U.S. NUCLEAR REGULATORY COMMISSION

Report No. 50-333/82-13

Facility Name: James A. FitzPatrick Nuclear Power Plant

Inspection on June 14-18, 1982 (Inspection Report 50-333/82-13)

FIGURE 1

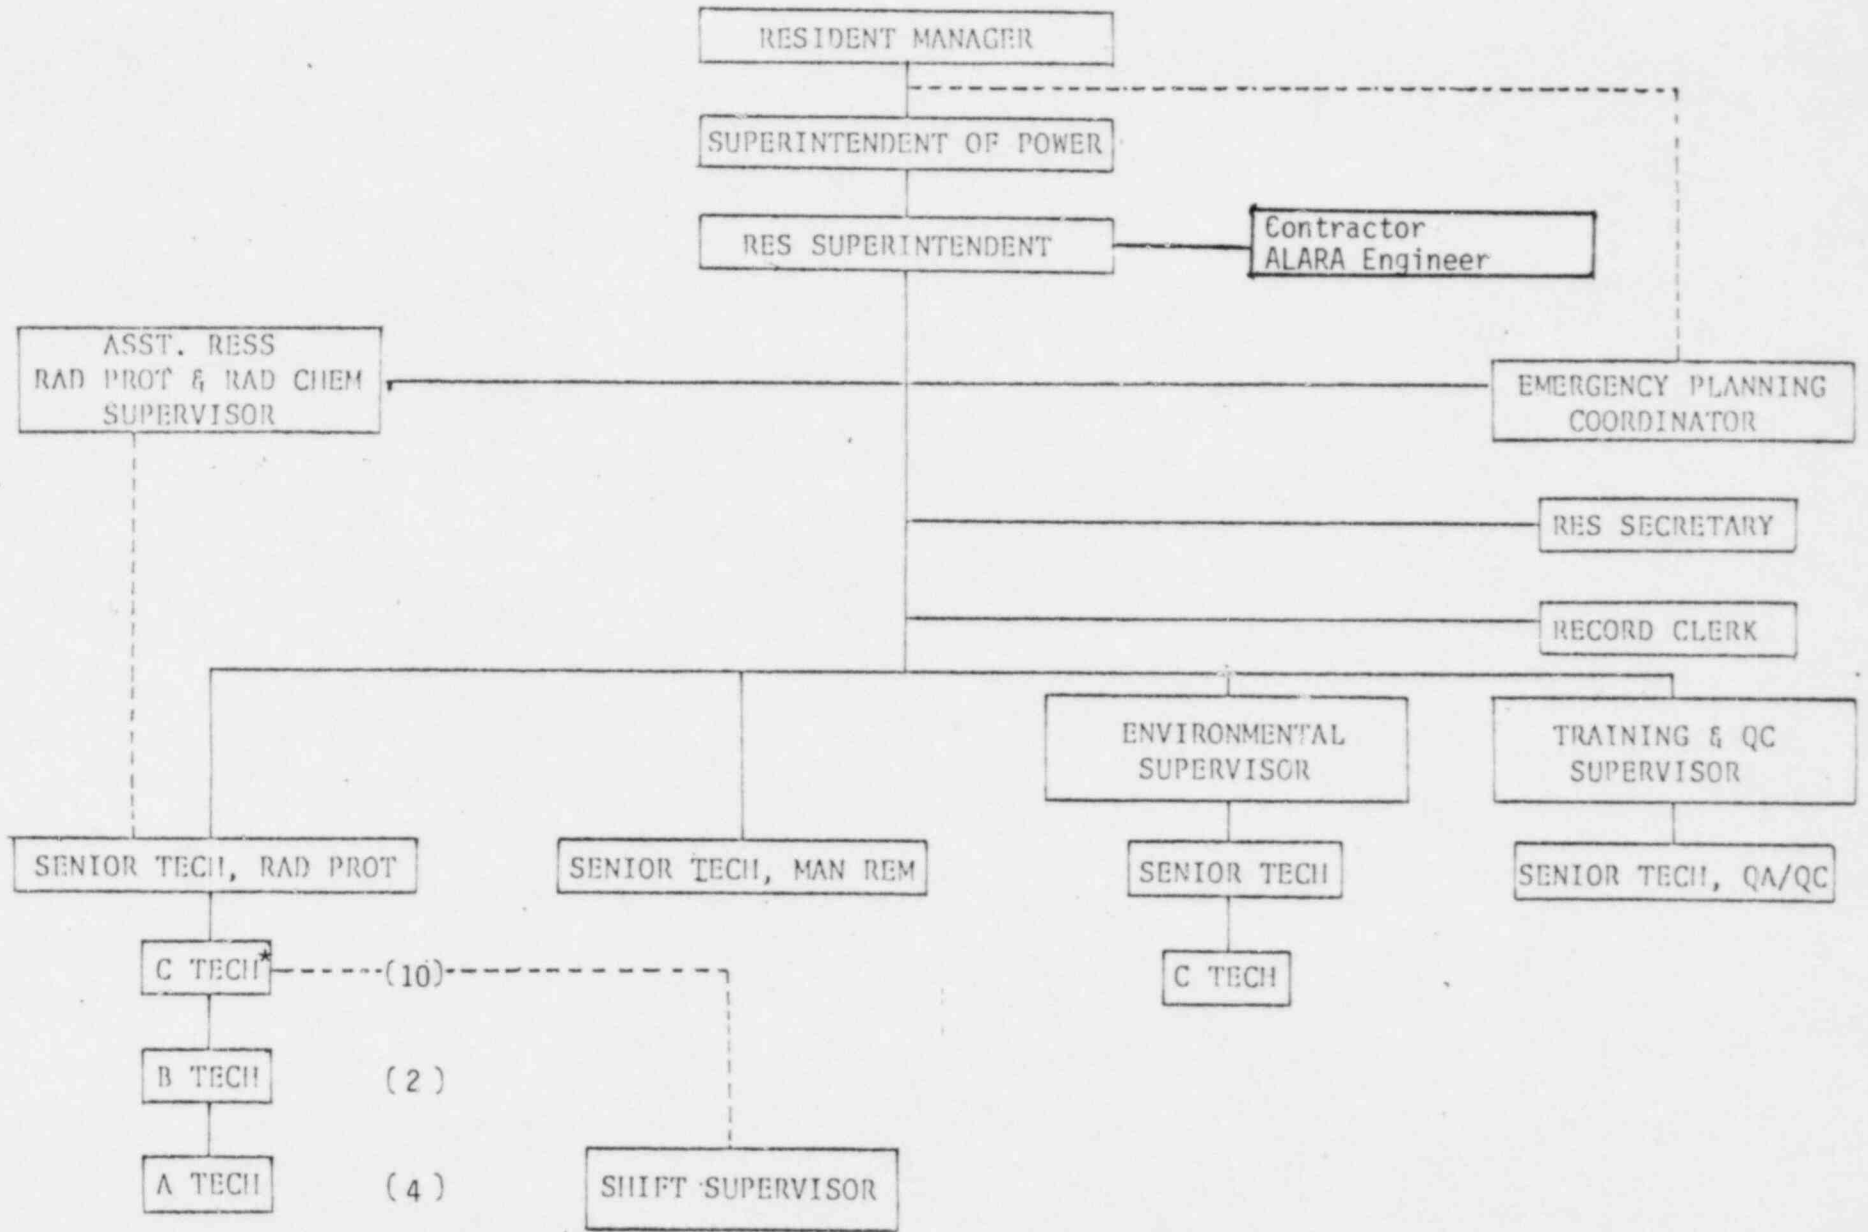
At the time of the inspection, the licensee Radiological and Environmental Services (RES) Department organization was structured as shown in Figure 1. Formal job descriptions for the RES department did not cover the following activities and personnel:

- Respiratory Protection Program. The Respiratory Protection Program is currently conducted by personnel from the following departments: RES (equipment procurement, issuance, storage, maintenance, and inspection), Training (worker training and fit testing), and Maintenance (equipment decontamination and cleaning). In the RES department, respiratory protection responsibilities are further divided between the Assistant Radiological and Environmental Services Superintendent

- Dosimetry and Radiation Protection. Senior Technicians currently function as first line supervisors in these areas. However, no formal assignment of supervisory responsibilities have been made to the senior technicians (see section 3.1.2).

- ALARA Program. The licensee currently employs a contractor engineer to oversee the ALARA program. However, there is no formal description of the duties and responsibilities of this individual.

At the exit meeting, the licensee stated that functional responsibilities covering all aspects of the respiratory protection program will be formally assigned by July 1, 1982, and that responsibility for the entire program will be assigned to a single, qualified RES supervisor, although segments of the program may be routinely performed by other departments.

At the exit meeting, the licensee stated that a plan to reorganize the RES department will shortly be submitted to licensee corporate management for approval and should be in place by December 31, 1982. In the interim, the licensee stated that all major functional areas in the RES department will be included in supervisory-level job descriptions and that senior technicians in charge of the dosimetry and radiation protection programs will be made aware of their job responsibilities.

At the exit meeting, the licensee stated that as part of the reorganization, ALARA functional job responsibilities will be formally assigned in supervisory level job descriptions and that the ALARA engineer would be made aware of his job responsibilities.
